APPLICANT: Louisiana Power and Light Company
FACILITY: Waterford 3
FROM: J. H. Wilson, Project Manager, Licensee Branch No. 3, DL
SUBJECT: MEETING SUMMARY FOR LP&L'S PRESENTATION OF BASEMAT ADEQUACY
AT WATERFORD 3

As part of the NRC Staff's review of the Waterford 3 basemat design and to facilitate LP&L's preparation for the March 26th meeting, a list of 32 questions was prepared and transmitted to LP&L. These questions are shown on Attachment III.

QUESTIONS ON WATERFORD 3 BASEMAT
3/26 MEETING IN BETHESDA

LP&L DRAFT RESPONSE TO USNRC QUESTIONS

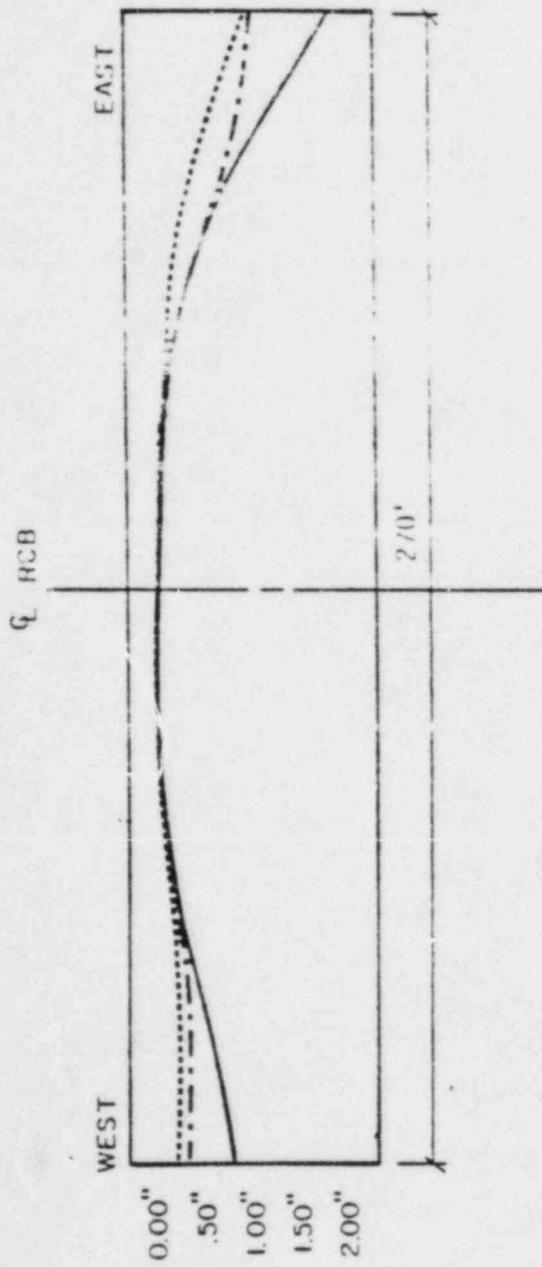
2. Where was water table when 1977 cracks were discovered?

Response:

At the time of discovery the ground water in the shell fill beneath the mat was at about elevation -20 ft. or about 15 feet above the top of the mat. (FSAR Figure 2.5-113: "Piezometer, Heave Point and Extensometer Responses Sh. 3 of 5).

LOUISIANA POWER & LIGHT CO.
 Waterford Steam Electric Station
 PIEZOMETER, HEAVE POINT AND
 EXTENSOMETER RESPONSES
 SHEET 1 OF 6
 FIGURE 2.6.113

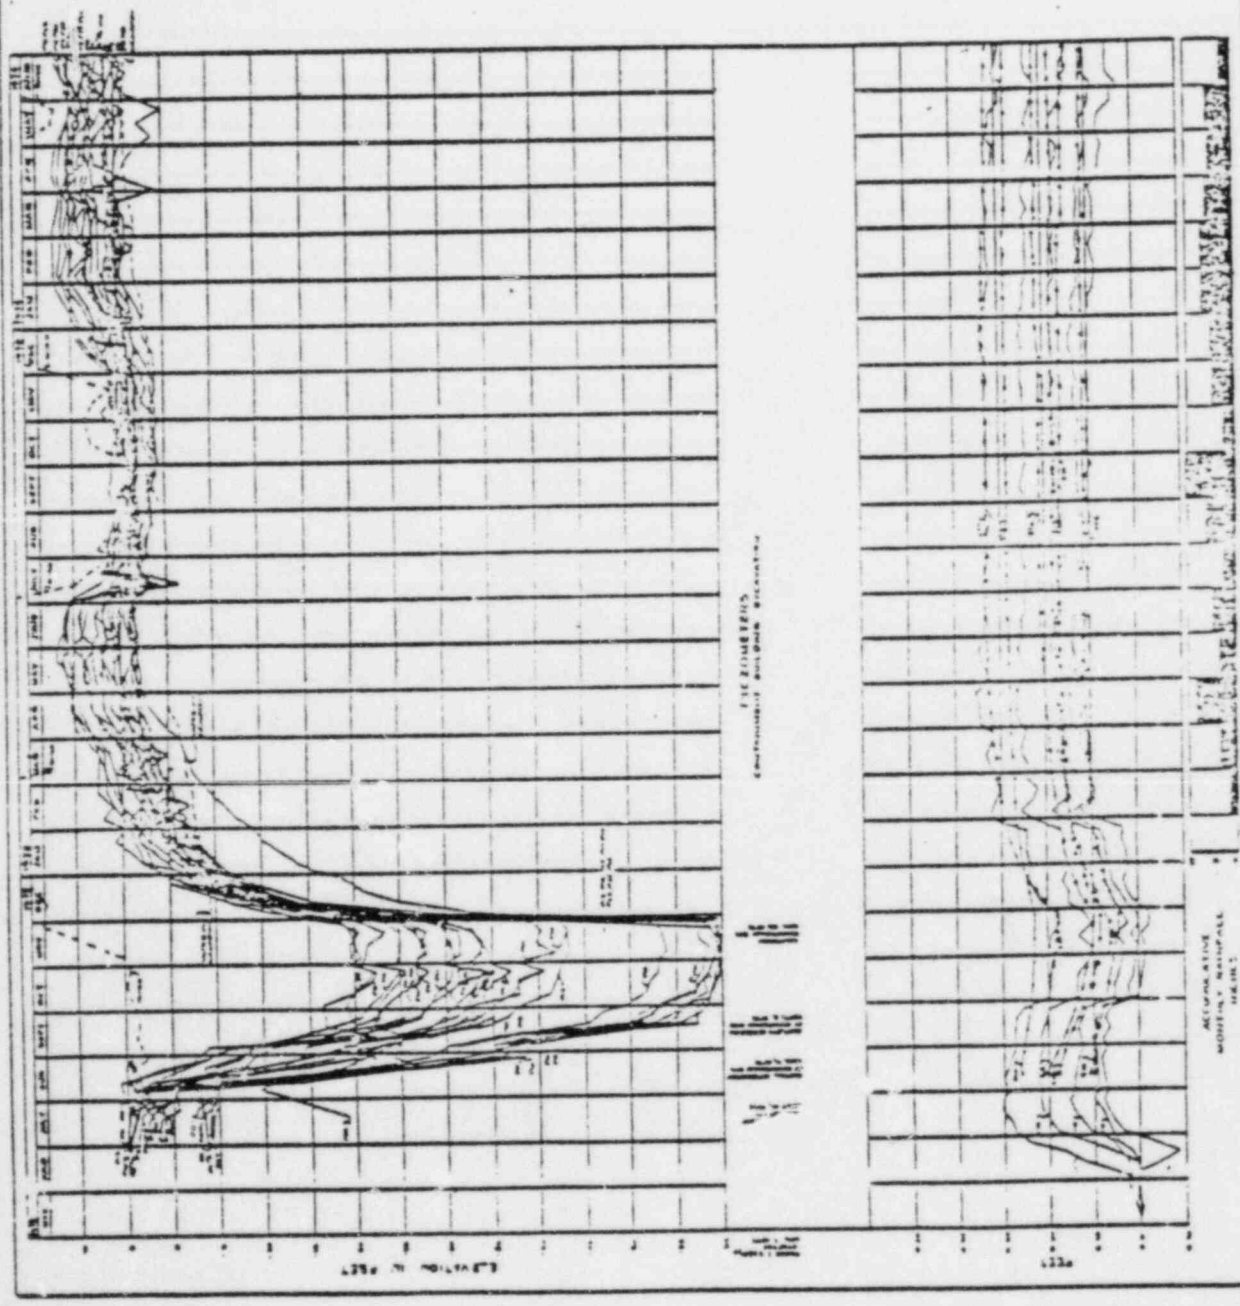
5. a) Provide complete documentation of groundwater cont. 1 and foundation heave from the start of dewatering until the present time. b) Include the history of soil excavation and backfill beneath the mat.

Response: 5a)

Groundwater control and foundation heave from the start of dewatering until recent time are exhibited in FSAR Fig. 2.5-113 (sheets 1/5 to 5/5).

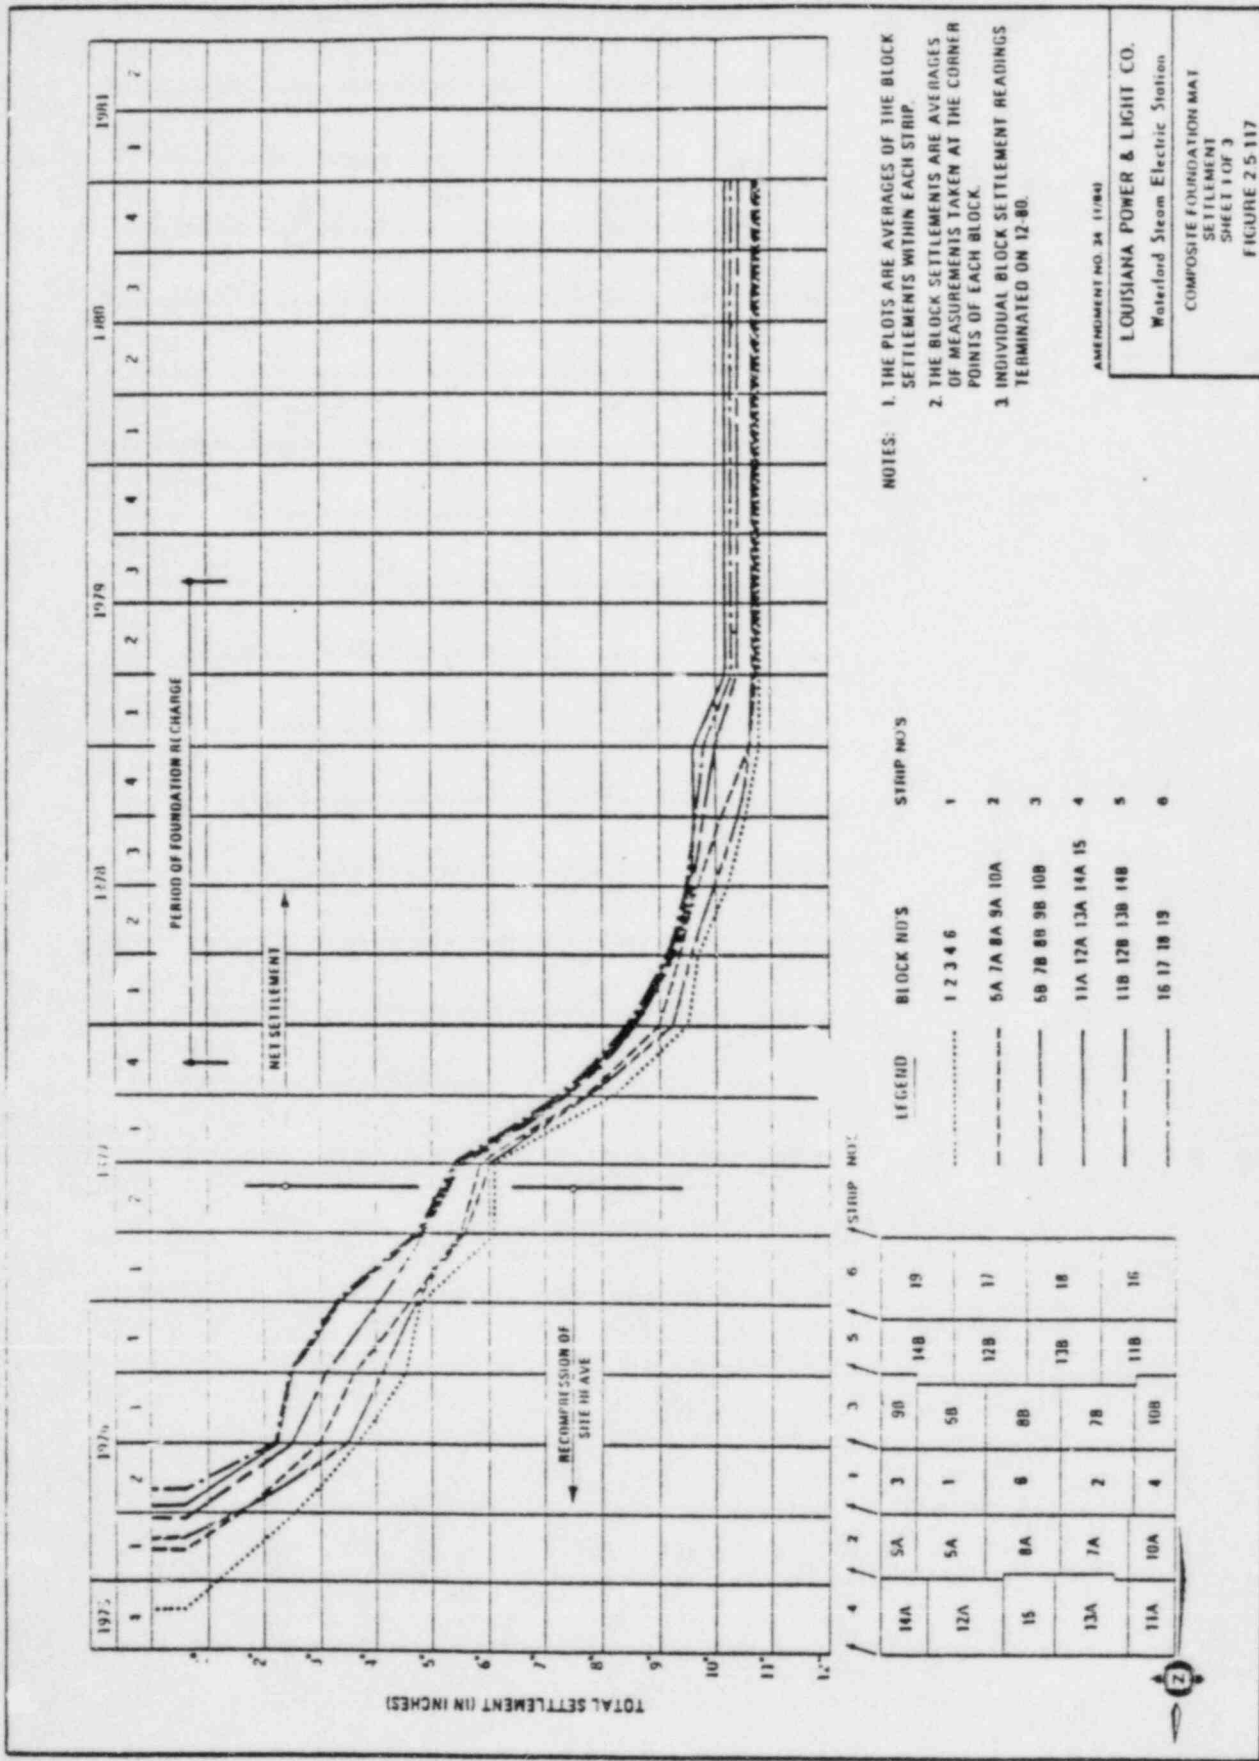
6. Provide the foundation loading history under each block during construction of the mat and walls. This should include the distribution of pressure under each block. Include the location and history of loads due to backfilling adjacent to foundation blocks.

Response:

A computer program was developed and maintained weekly to monitor the placements made. Accumulative soil stresses were identified and maximum/minimum total stresses were noted. These figures and the differential stresses were reviewed. Differential stress did not exceed the maximum allowable of 1.0 KSF.

As can be noted on the Composite Foundation Mat Settlement (Figure 2.5-117 in the FSAR), recharging of the water table began in late 1977 and was gradually charged until completion in late 1979. Recharging commenced based on total stresses achieving the 4.5 KSF criteria. The initiation of recharging the mat was approximately week no. 85 of construction.
